**U2000A-03**

**S E R V I C E N O T E**

U2000A 10MHz – 18GHz USB Sensor

**Difficulty to attach USB power sensor cable to power sensor unit.**

Figure 1: USB power sensor cable fully attached to power sensor unit

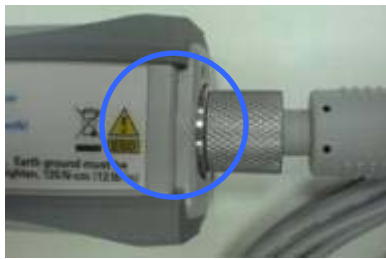
When the USB power sensor cable is attached to the power sensor unit, user may find it difficult to attach the cable to the power sensor unit.

If user faces difficulty to attach the cable to the power sensor unit, kindly contact Agilent for free of charge cable replacement. Kindly scrap the used cable.
